CURRAGH RESOURCES INC.

SUBJECT: Dy Decline Drilling

SUBJECT: DY DECLINE DRILLING

*Dy Deposit
Underground
Decline*

PLEASE NOTE SURVEY POSITION OF PORTAL

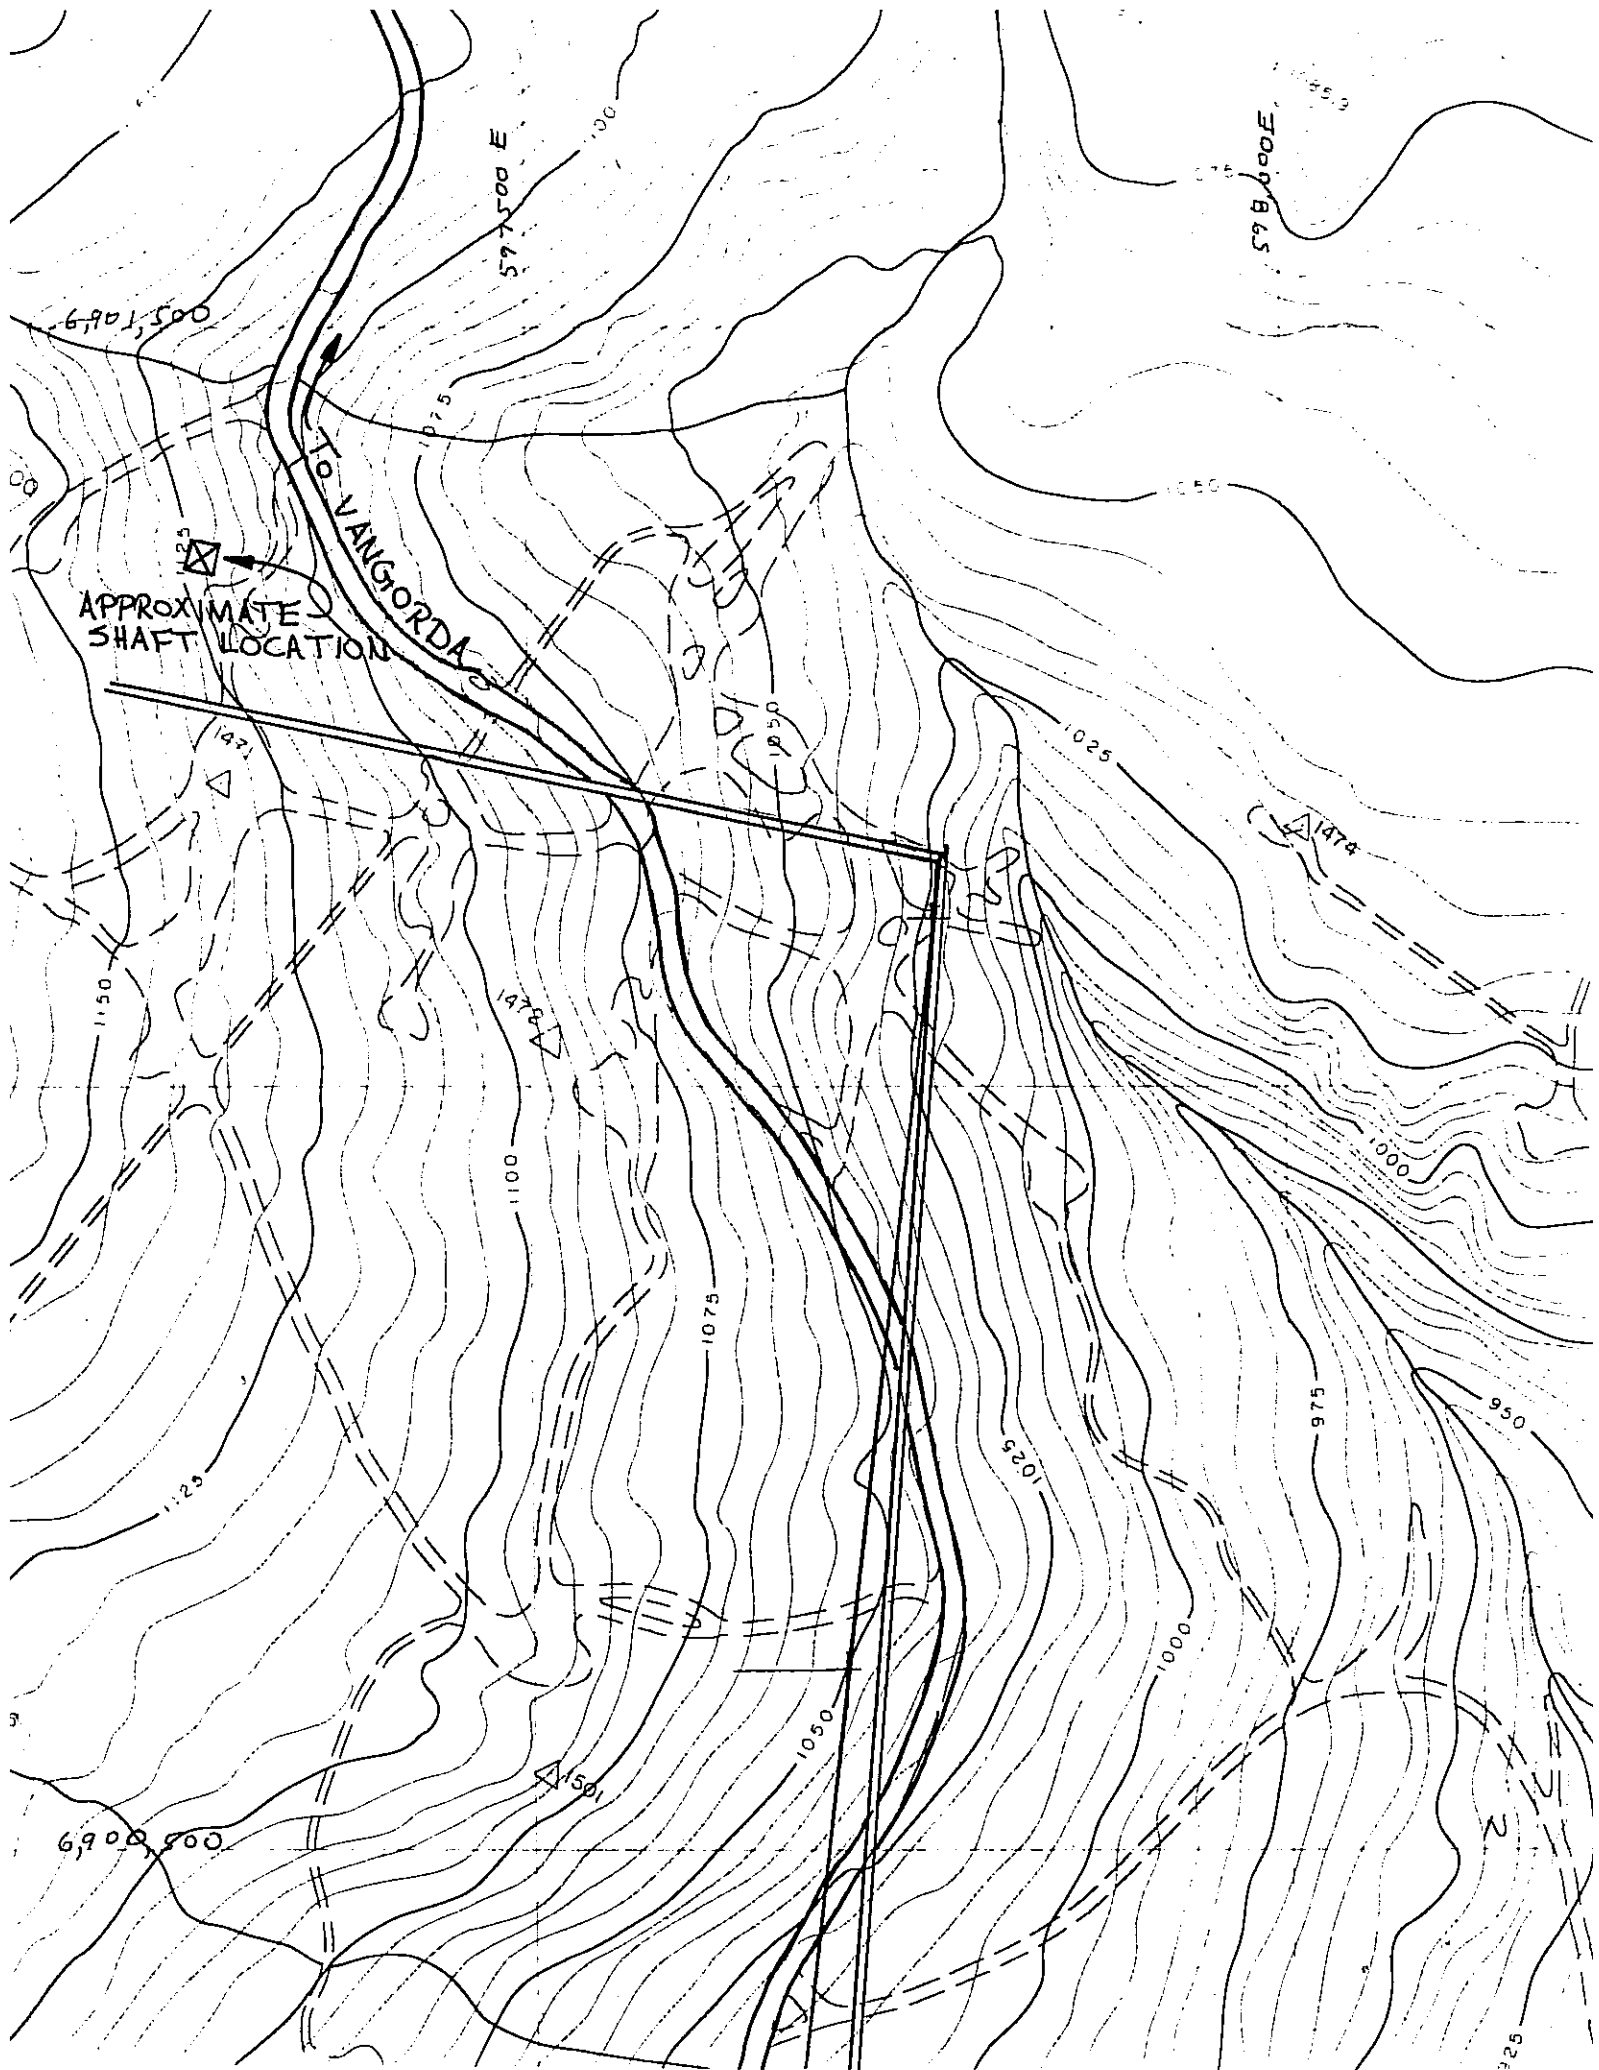
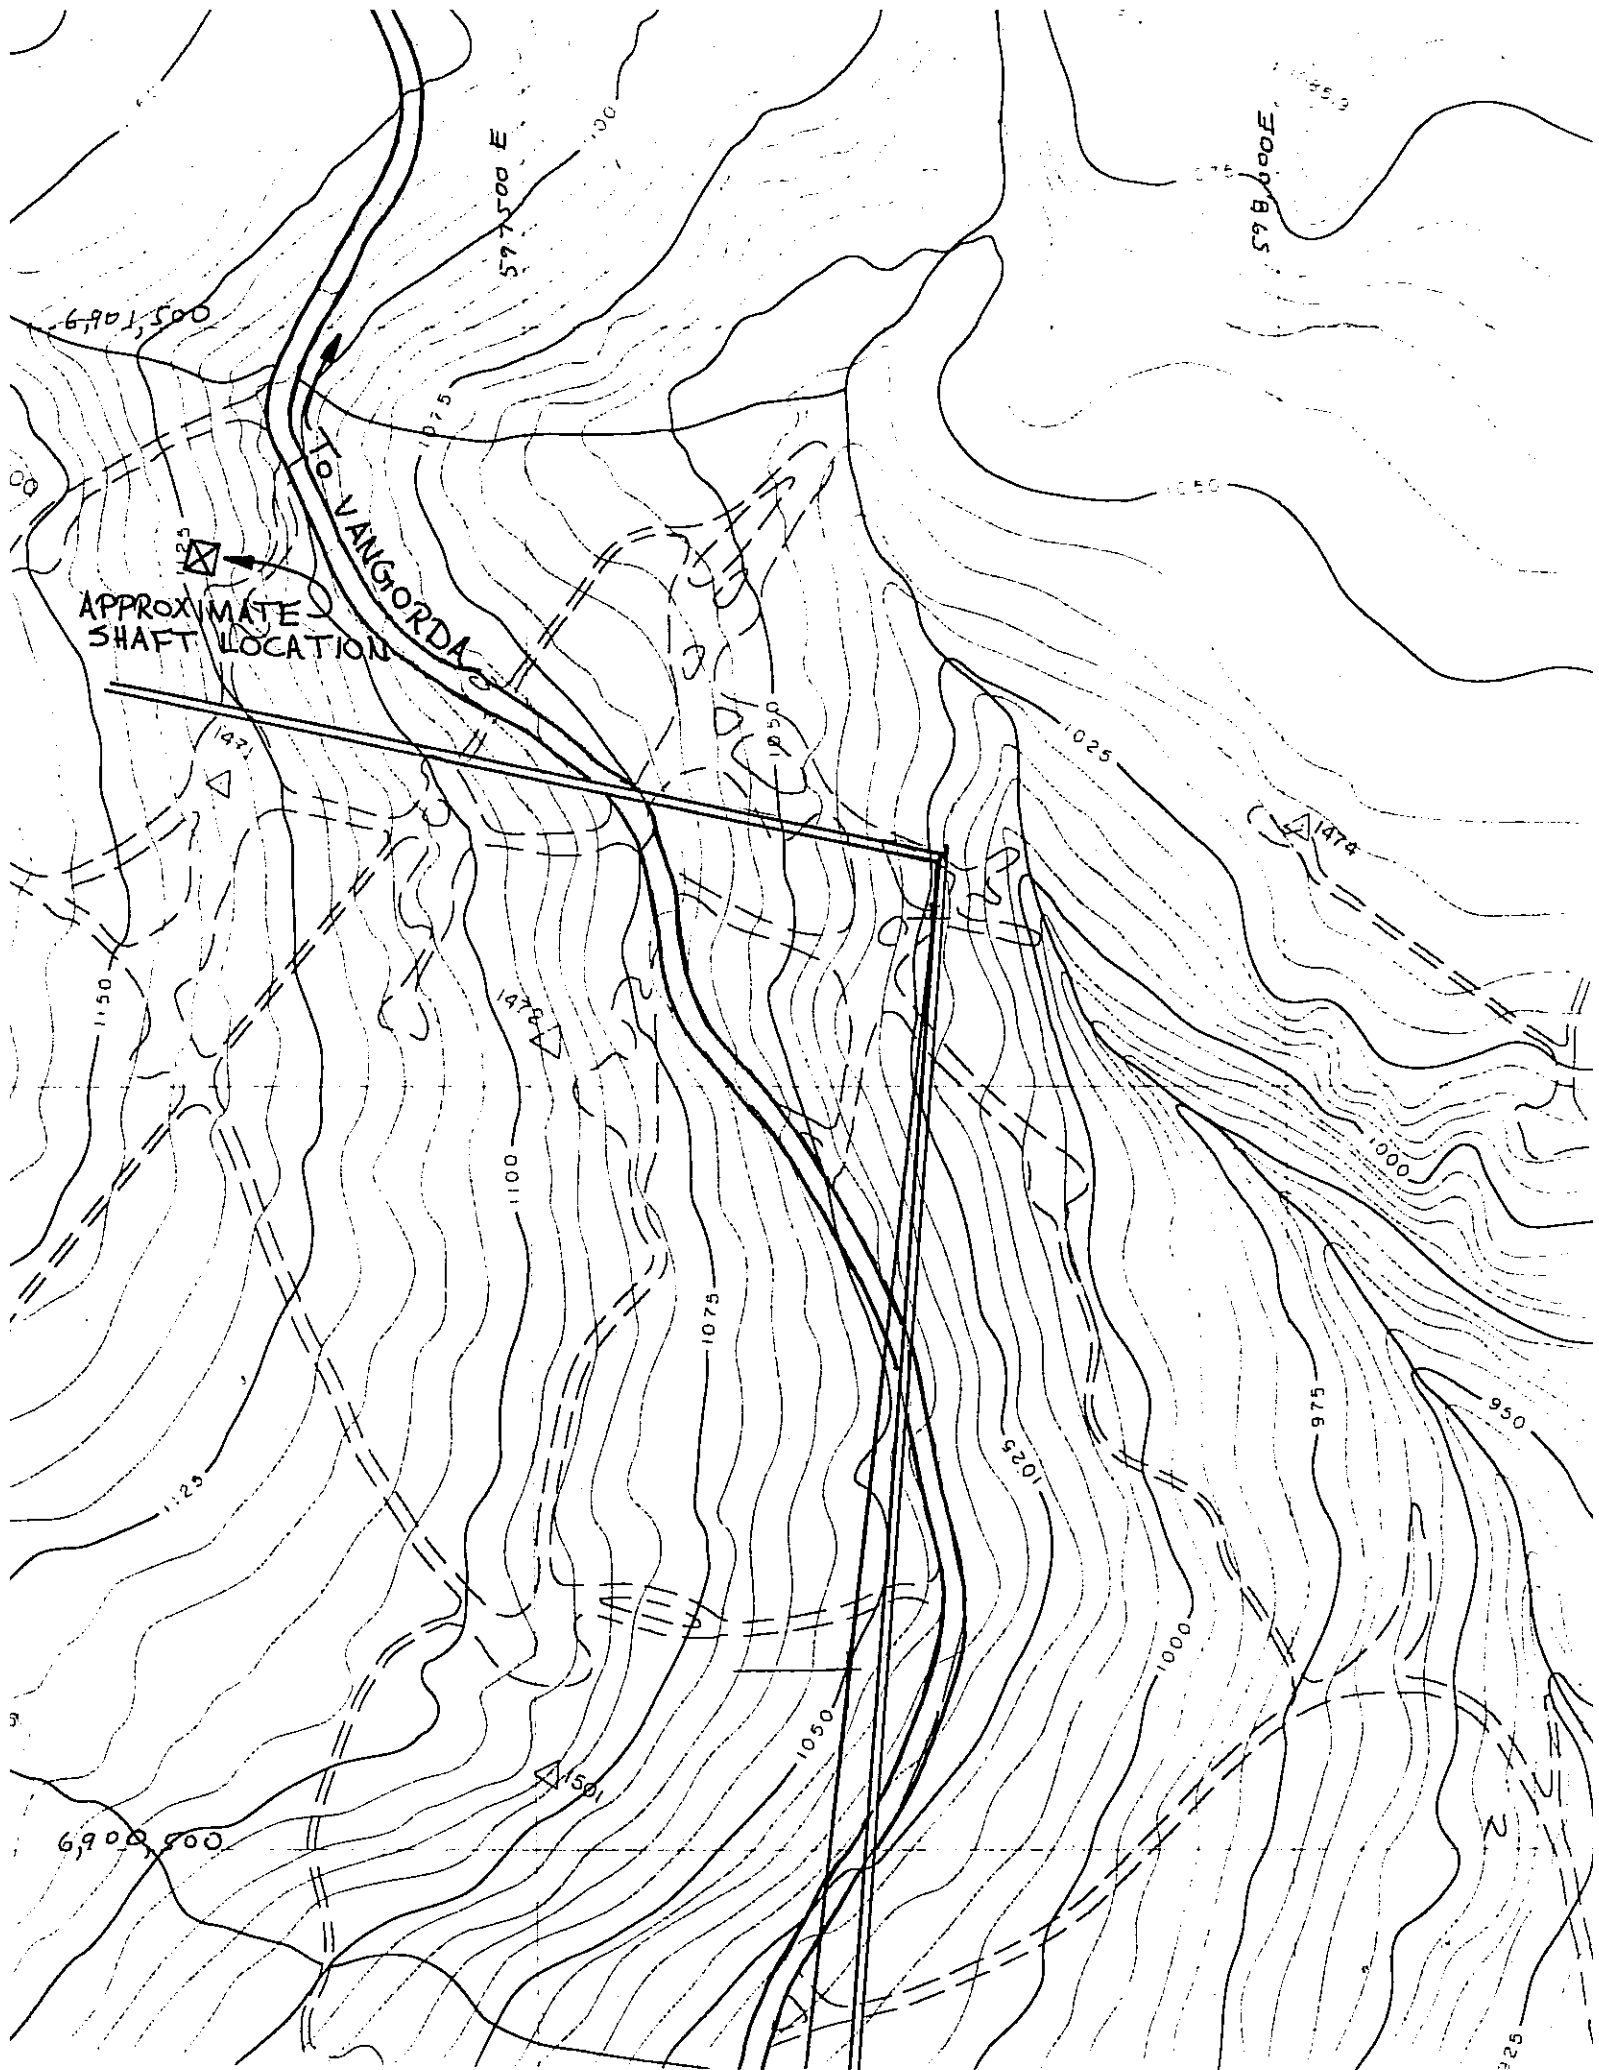
THE DECLINE, IF DONE THIS WAY WILL BE 2,064m long with a -9° plunge

THE ORIGINAL LOCATION CMD DESIGN PORTAL WAS 1,792m LONG with a -11.5° plunge

THE DIFFERENCE IS 272m or approximately three-quarters of a million dollars
OF EXTRA EXCAVATION.
